Release Notes MLTG-CN

Version: 1.4.1-00209-5f349dd

Enhanced from version 1.4.0-00123-7e047ba

Security configuration

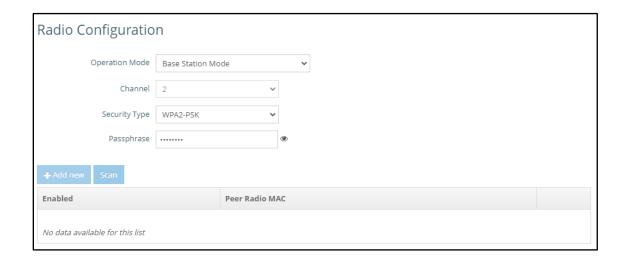
Security configuration for the wireless link is supported now. In current version, WPA2-PSK is the only supported security type. Passphrase is configurable and will be applied to all links of the node. The security settings must be the same for the two peers of a link. If the passphrase does not match, then the link cannot be established.

2. Ethernet Settings

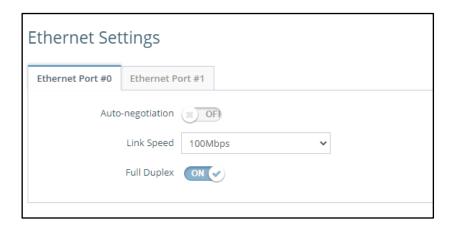
Ethernet settings page is added. For each port, auto-negotiation can be disabled and configured as fixed link speed and duplex option.
